**APPLICATION NO:** 21/2017/0045/ PF

**PROPOSAL:** Erection of replacement dwelling

**LOCATION:** 4 Bryn Artro Avenue Llanferres Mold

Client: Mr. J. Carter  
 Project: Replacement 3 Bedroom Dwelling  
 Address: 4 Bray Drive Avenue  
 Tabernash, CO 80551  
**Plans and Elevations as Proposed**

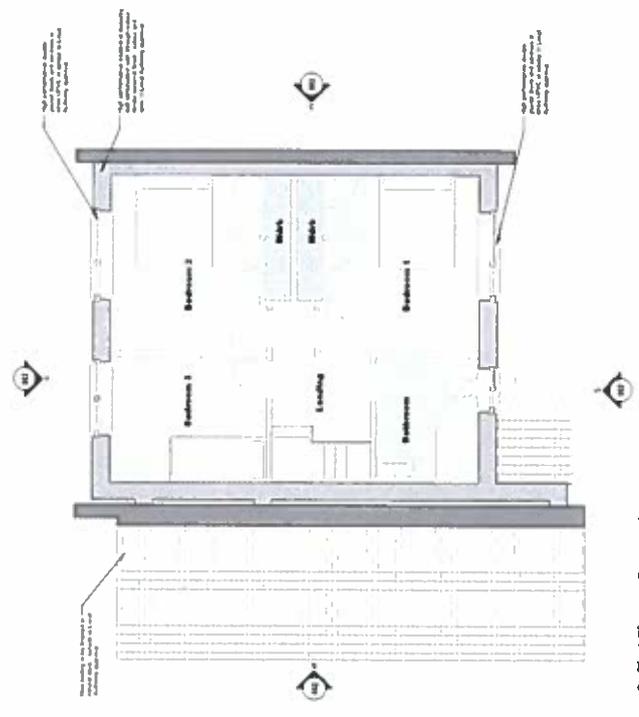
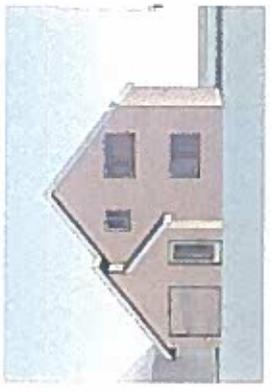
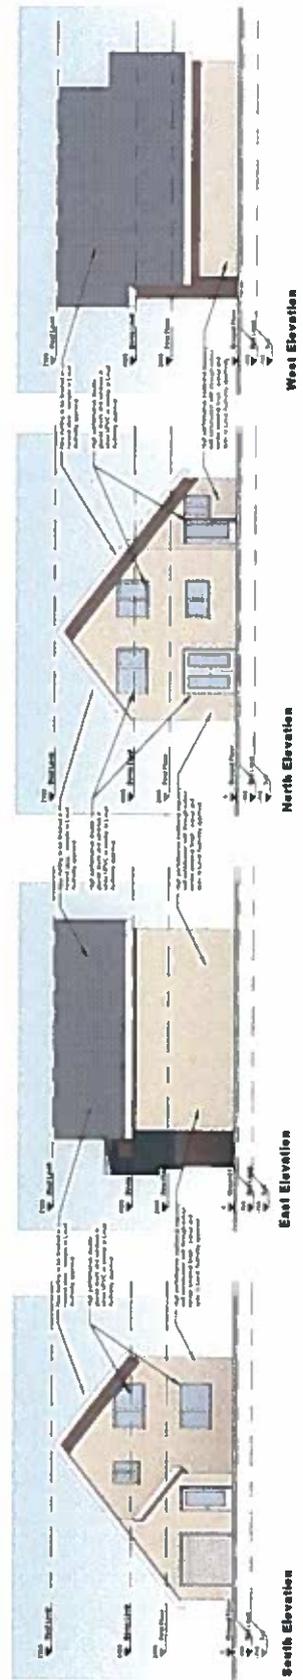
"This is the last of the existing sub-standard dwellings on Bryn Artro Avenue to be replaced, and the Joint Committee has no objection in principle to its replacement. The design and appearance of the replacement dwelling is disappointingly suburban in character and the committee would have preferred an alternative design. However, the proposed materials and overall mass of the structure are consistent with the existing street scene and, in this context, the committee has no further observations to make on the design. The existing hedge along the rear boundary should be retained to help integrate the development into its rural setting."
